1) SAA Dive Planner / RNT Section:

## 3) SAA Nitrox Diver:

## 4) Out of the Decompression Matrix:

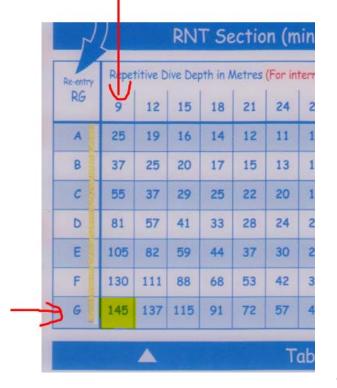
Bühlmanns original value (p. 235 in "Tauchmedizin", Albert A. Bühlmann, Ernst B. Völlm (Mitarbeiter), P. Nussberger; 5. Auflage in 2002, Springer, ISBN 3-540-42979-4) reads "154"

,00. 01

(taken in the passengers cabin during a standard intercontinental flight) So it should read 8000 feet, probably.
